TECHNICAL BULLETIN: BISON BEDE LTD.

TECHNICAL BULLETIN

Chassis Plate modification

Ref. Footrest fixing support boss Bison Bede Classic Straight Stairlift

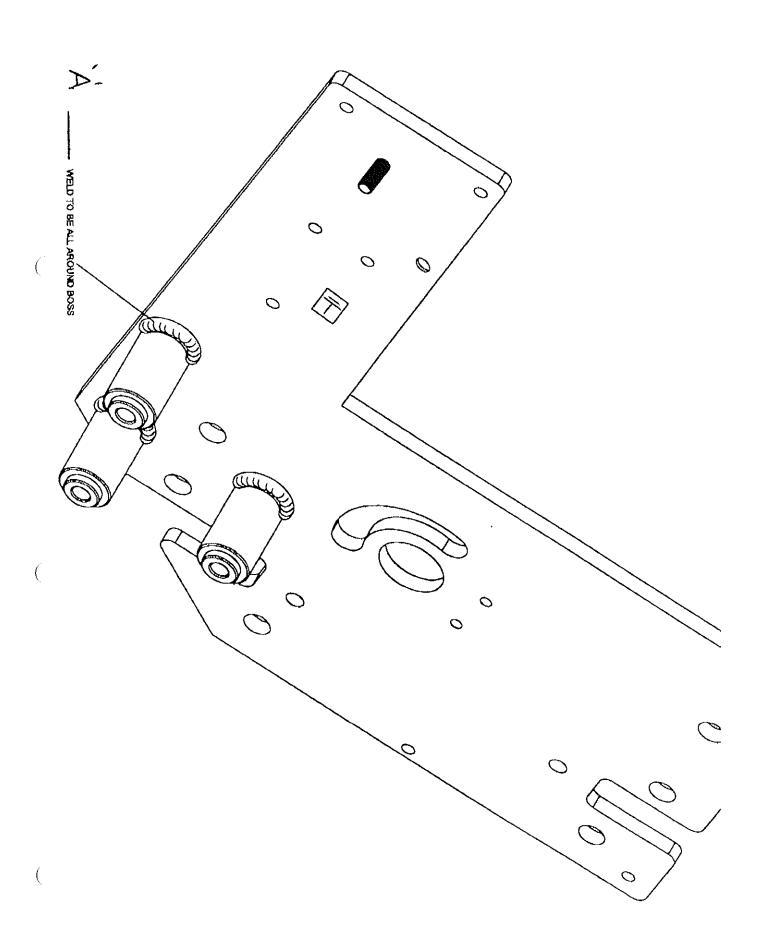
The original design did not have a full weld at "A" and no weld on the reverse side of the plate.

The MODIFIED boss has both a full weld at the front and a puddle weld on the reverse side, the latter being dressed back as indicated on page 4.

stro-Fit on Classic Straight Lifts.

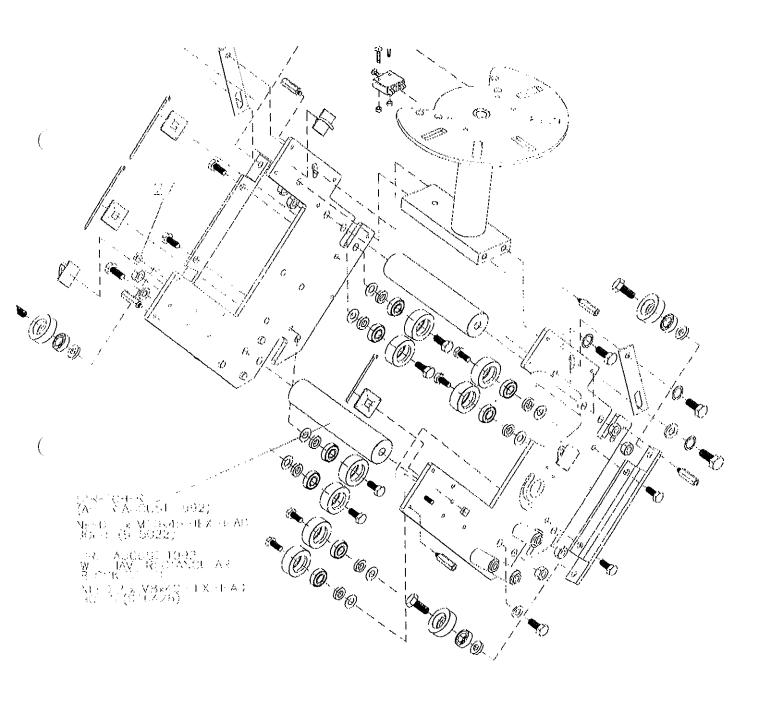
place Footrest Side Chassis Plate upon inspection if finding NO CONTINUOUS weld on front e. See page 2

pending upon age and quality of lift - Chassis Plate on the footrest side only is to be removed d recaced with either RD2069 or RD2070 (depending on handing) and a hole drilled to suit e age of plate.
